APPLICATION NO.	FILING DATE	FIRST NAMED INVENTOR	ATTORNEY DOCKET NO.	CONFIRMATION NO.
10/600,094	06/20/2003	Daniel D. Nemcek	117205-1	9168
21324	7590	03/16/2005	EXAMINER	
HAHN LOESER & PARKS, LLP			BALSIS, SHAY L	
One GOJO Plaza			ART UNIT	
Suite 300			PAPER NUMBER	
AKRON, OH 44311-1076			1744

Office Action Summary

DETAILED ACTION

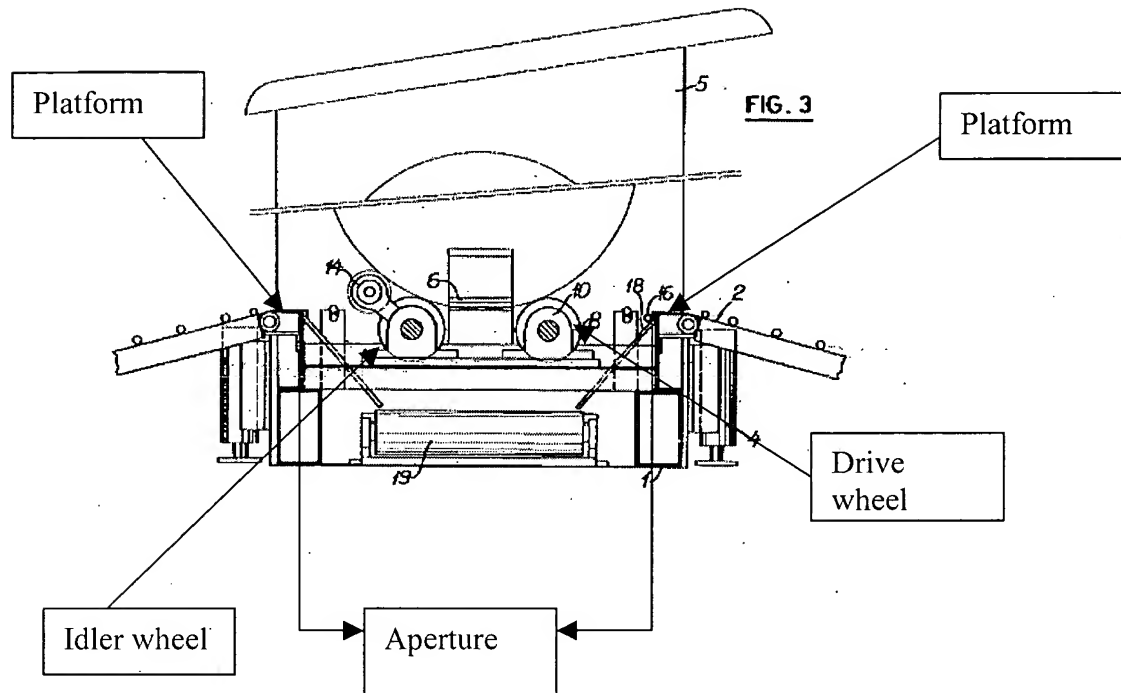
With regards to claims 1 and 9, Kuster teaches a wheel cleaner comprising a platform (figure 3, darkened lines, see figure below), a motor (figure 2, element 11) and a drive member (figure 2, element 8). The drive member is operably attached to the motor and is adapted to rotate the wheel positioned on the platform. There is at least one cleaning member (figure, 3, element 14) positioned above the platform to clean the tread of the wheel. Kuster teaches all the essential elements of the claimed invention however fails to teach that the cleaning member cleans the inner and outer surfaces of the wheel as well. Randrup teaches a wheel cleaner comprising a cleaning member for cleaning the inner and outer surfaces of the wheel (figure 3,

With regards to claim 2, Kuster teaches that the platform comprises at least one aperture (see figure below).

With regards to claim 3, Kuster teaches an idler wheel adjacent each drive member (see figure below).
